| Product hierarchy no. * | | | | Part no. | SBU | Type / Description | Customer part no. |
|-------------------------|-----|-----|------------|----------------|--------------------------------|--------------------|-------------------|
| 02 | 005 | 016 | 0000001103 | See list below | Power Entry Modules w/o Filter | 6200 | |

2 Type of change

| Product Change Notification | | | | | PCN 6200 | | |

| Old product appearance | | New product appearance | |
|--|--|------------------------|--|
| <p>Snap-in mounting; Old</p> <p>Fuse insert from top side</p>  | <p>Snap-in mounting; New</p> <p>Fuse insert from bottom side</p>  | | |

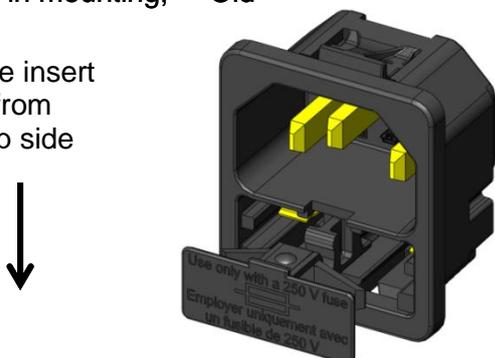
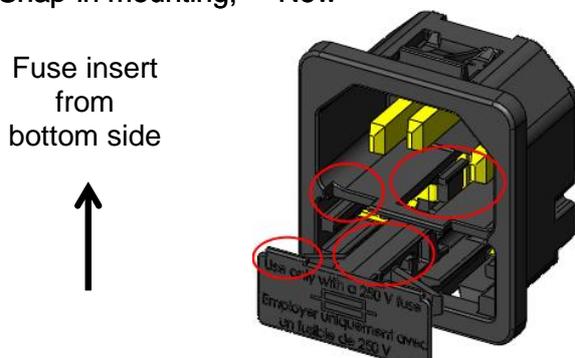
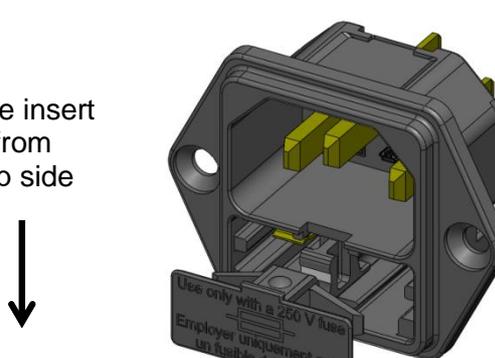
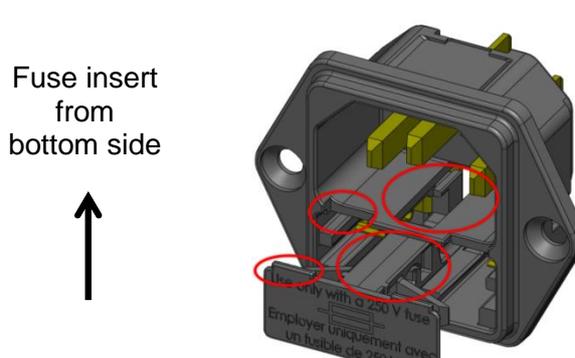
| Old product appearance | | New product appearance | |
|--|--|------------------------|--|
| <ul style="list-style-type: none"> - Slot for V-Lock cord retention - Fuse assembling from opposite side - Fusedrawer has two latches on the side to pull-out the fusedrawer, until now is only one latch | | | |
| <p>Screw-on mounting; Old</p> <p>Fuse insert from top side</p>  | <p>Screw-on mounting; New</p> <p>Fuse insert from bottom side</p>  | | |

| Form | Yes | - Slot (notch) for V-Lock cord retention - Insertion of the fuse is turned - Fusedrawer has 2 latches sideways |

| Old product approval marks | New product approval marks |

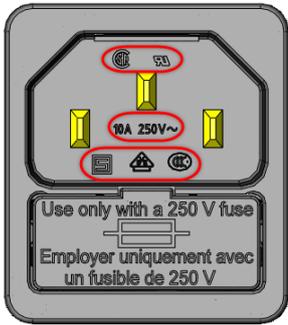
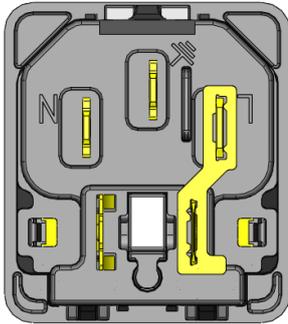
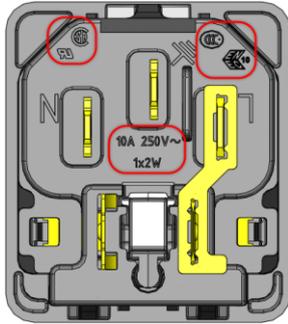
| Old product approval marks | New product approval marks |
|---|---|
| <p>Picture shows snap-in mounting, change also applies to screw version. All approval and rating marks are new on the rear side</p> | |
| <p>Old;</p>   | <p>New;</p>   |

| Product Label | Yes | VDE mark replaced by ENEC10 |
